# Tsi107™ Revision 1.3/1.4 Device Differences

80C2000\_AN002\_02

This document describes electrical and functional differences between Revision 1.3 and Revision 1.4 of the Tsi107 PowerPC Host Bridge, which provides system interconnect between PowerPC processors, PCI peripherals and local memory.

Figure 1. Rev 1.3 and Rev 1.4  $\overline{DBGn}$  Signal Timing

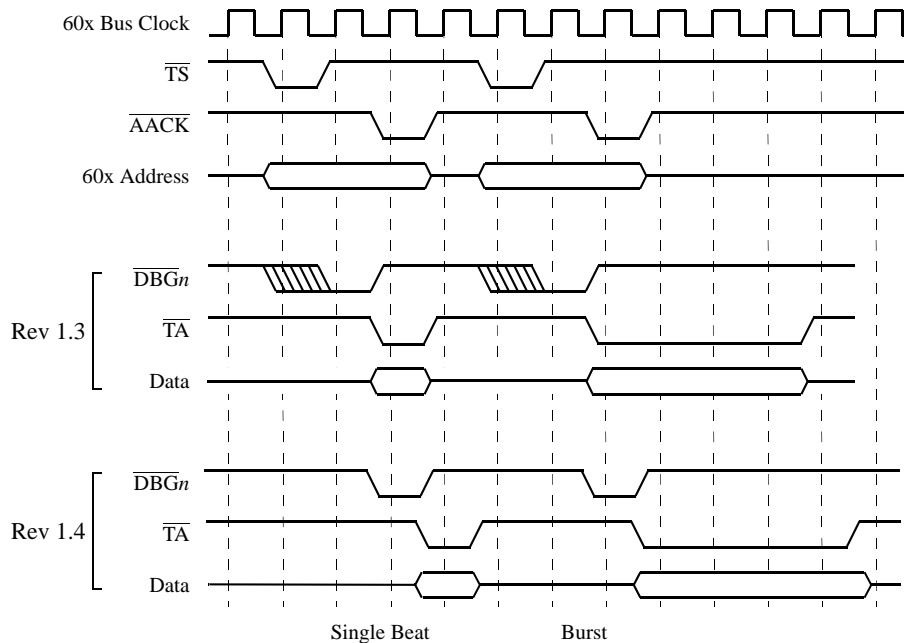
As described in Section 3.2, “MPC7450 Compatibility,” to guarantee that  $\overline{TA}$  is not asserted on or before  $\overline{AACK}$ , the timings for  $\overline{DBGn}$  and  $\overline{DBGLB}$  were changed in Rev 1.4 to fix the MPC7450-compatibility problem. Before Rev 1.4, the Tsi107 may drive  $\overline{DBGn}$  (and  $\overline{DBGLB}$ ) as early as the cycle in which  $\overline{TS}$  is asserted. Figure 1 shows the signal timing for  $\overline{DBGn}$  and  $\overline{DBGLB}$  on Rev 1.3 and Rev 1.4 devices.

For Rev 1.4 of the Tsi107,  $\overline{DBGn}$  is asserted coincident with  $\overline{AACK}$ . If a Rev 1.3 system design incorporates external logic that depends on the timing of  $\overline{DBGn}$  or  $\overline{DBGLB}$ , the external logic must be modified to accommodate the altered timing of Rev 1.4.
